OFFICIAL NOTICE NO. 105

Addendum No. 1

This Addendum # 1 is to replace the existing special provisions with the attached special provisions, to change the completion date to November 21, 2014, and to add the following bid items:

W. Clybourn St. - a point east of N. 16th St. to N. 16th St. (median)

ADJUSTING CUC MANHOLE COVERS

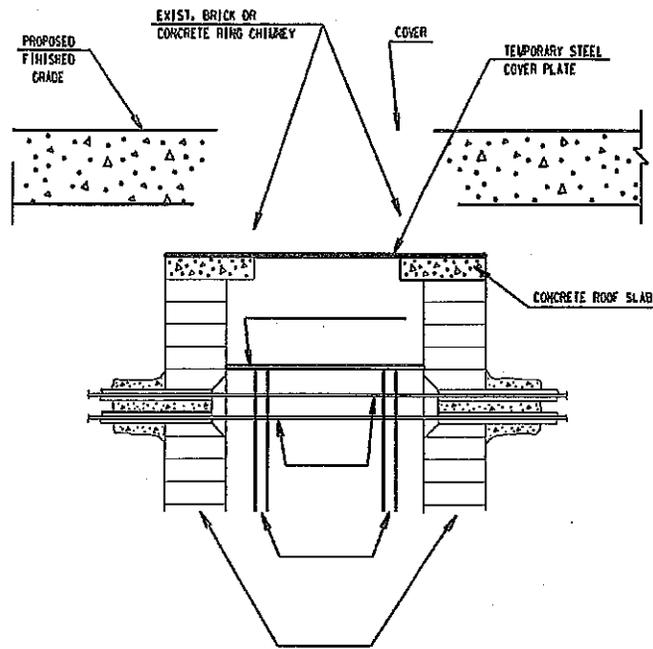
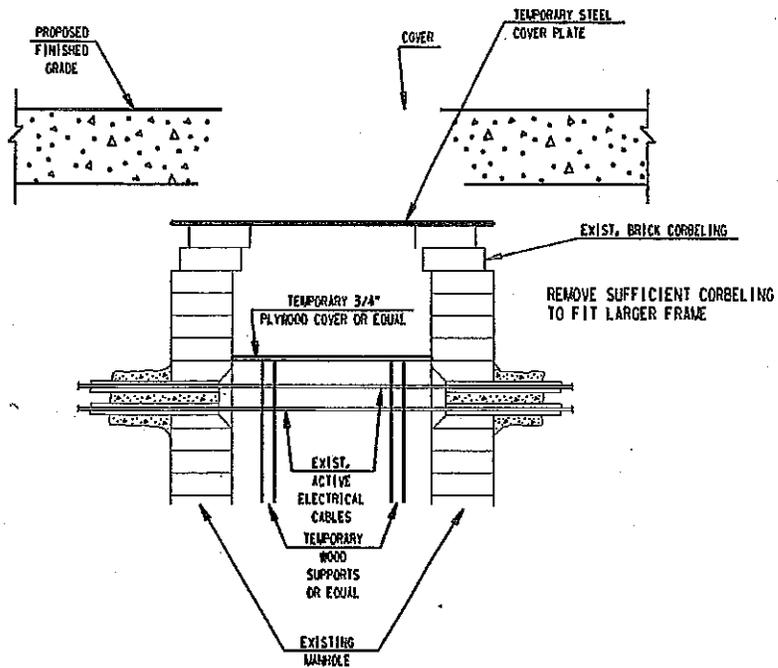
This special provision describes adjusting the existing chimney of the block, pre-cast, or brick round manholes; and furnishing, installing, and removing protection of the cables in the manholes during adjustment and paving operations. Perform work in accordance with the standard specifications, per *Standard Specifications for Sewer & Water Construction in Wisconsin*, as shown on the attached sketch, and as hereinafter specified.
